#### HISTORIC AND DESIGN REVIEW COMMISSION

HDRC CASE NO: 2017-019

**ADDRESS:** 220 HERMINE BLVD

OWNER: Chet Graham, Kristin Graham
TYPE OF WORK: Construct addition and rear carport

WEST SIDE VIEW OF APPITION

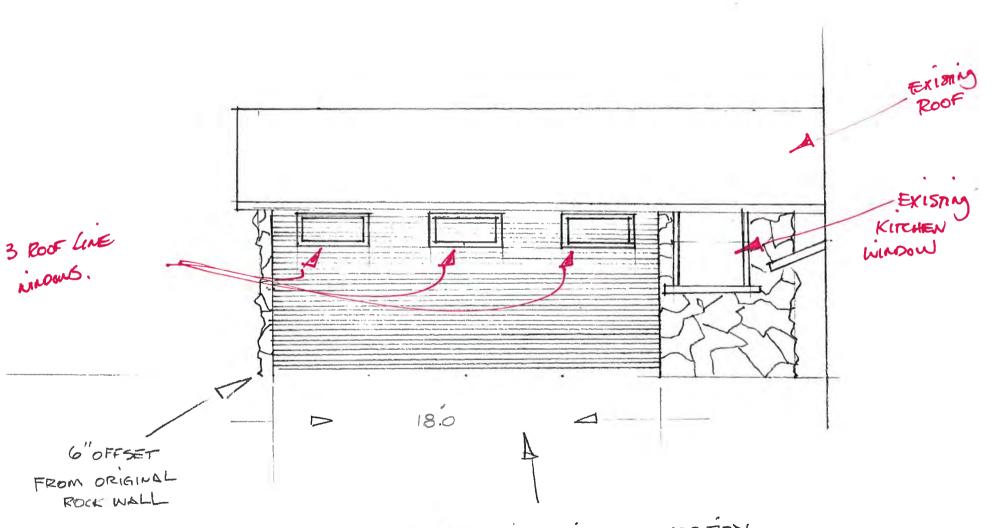
- d. ARCHITECTURAL DETAILS The main structure has wood one over one windows and a rear wood door with half

window light. The proposed addition will obscure 1 one over one window and the rear door. The addition will use a salvaged solid wood door with square panels and install 3 horizontal rectangle windows. According to the Guidelines for Additions 4.Aii, incorporate details that are in keeping with the architectural style of the original structure. Details should be simple and compliment the character of the main structure. Staff finds the windows, doors and fenestration consistent with the main structure and the Guidelines.

- 1. That the windows on the addition be made of wood, inset 1 to 2 inches, and a section detail be submitted to staff prior to receiving a Certificate of Appropriateness.
- 2. That the roof of the accessory structure be made of composition shingles to be similar to the roof material on the main structure.
- 3. That a detail of the double doors on the shed be submitted to staff prior to receiving a Certificate of Appropriateness.
- 4. That the windows on the accessory structure be made of wood, inset 1 to 2 inches, and a section detail be submitted to staff prior to receiving a Certificate of Appropriateness.

SOUTH SIDE VIEW OF ADDITION

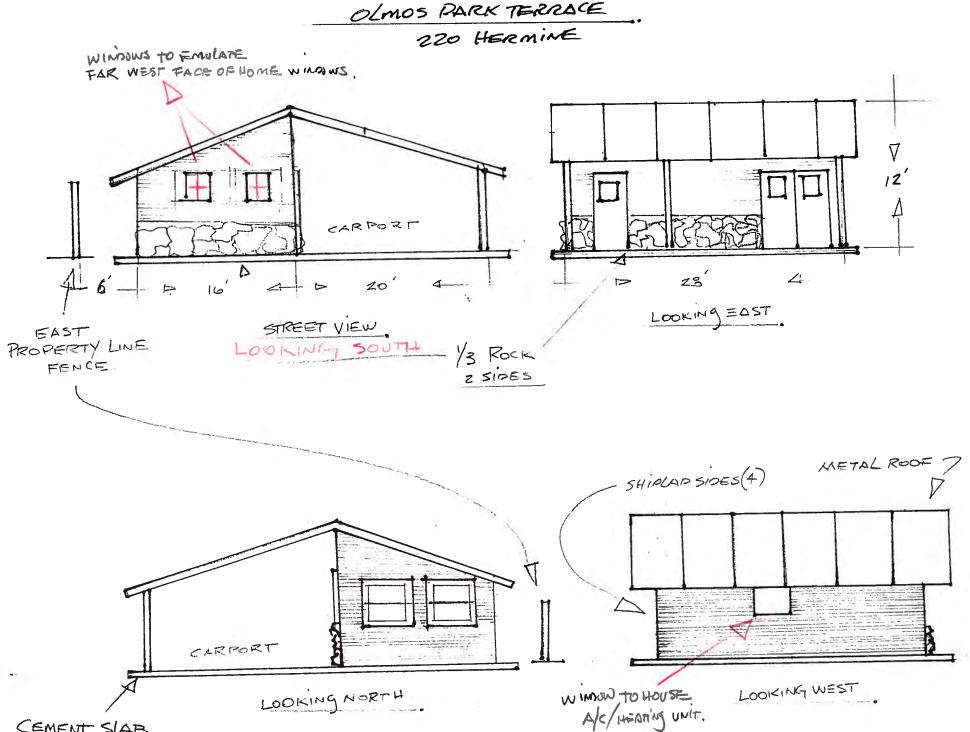
- b. SCALE, MASSING, AND FORM There is an existing rear covered porch with a shed roof, that is approximately 166 square feet. The proposed addition had a shed roof at the same height as the existing porch shed roof. The rear addition is approximately 200 square feet. According to the Guidelines for Additions 1., the addition should utilize a similar roof form, be subordinate to the principal façade, and be consistent with the height of the existing structure. Staff finds the proposed addition is consistent with the Guidelines as it is in the rear and in replace of an existing covered porch.

- c. MATERIALS The main structure includes stone, wood lap siding, and composition shingles. The proposed addition will include wood lap siding and composition shingles. According to the Guidelines for Addition 3.A.i., materials should match type, color, and offset to distinguish the addition from the main structure. The proposed addition is adjacent to a stone wall and offset 6" from the plane of the main structure. Staff finds the proposal consistent with the Guidelines.
